AMD-K6™

MMX™ Enhanced Processor

Revision Guide

Publication # 21266	Rev: E	Amendment/0
Issue Date: August 1997

Figure 1. AMD-K6™ Processor Assertion of **HLDA** Due to Simultaneous **BOFF#**/**HOLD** Assertion

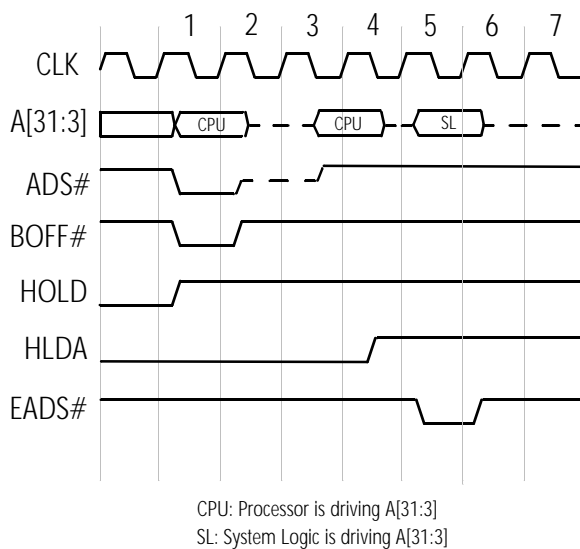
Normal Specified Operation. If **BOFF#** and **HOLD** are sampled asserted on the same clock edge that negates **ADS#**, the processor asserts **HLDA** one clock edge after **HOLD** is sampled asserted.

Non-conformance. If **BOFF#** and **HOLD** are sampled asserted on the same clock edge that negates **ADS#**, the processor asserts **HLDA** two clock edges after **HOLD** is sampled asserted.

Potential Effect on System. There are three potential effects of this erratum to consider:

- If the system logic asserts **BOFF#** for a duration of one clock, anticipates the assertion of **HLDA** in clock 3 (see Figure 1)—which is the normal specified operation—and drives the address bus and **EADS#** for an inquire cycle in clock 3, then the processor will not sample **EADS#** asserted. In addition, address bus contention will occur in clock 3.

- If the system logic asserts **BOFF#** for a duration of two clocks, anticipates the assertion of **HLDA** in clock 3, and drives the address bus and **EADS#** for an inquire cycle in clock 3, then the processor will not sample **EADS#** asserted. (No address bus contention occurs in this case.)

- If the system logic asserts **BOFF#** for a duration of one clock, anticipates the assertion of **HLDA** in clock 3, and drives the address bus and **EADS#** for an inquire cycle in clock 4, then address bus contention may occur in clock 4. (The processor will sample **EADS#** asserted in this case.)

If the processor does not sample **EADS#** asserted during an inquire cycle, cache/memory incoherency will occur. Address bus contention can affect the reliability of the processor and the system logic.

Suggested Workaround. The system logic must sample the assertion of **HLDA** before asserting **EADS#** and driving the address bus for an inquire cycle—as shown in clock 5 of Figure 1.
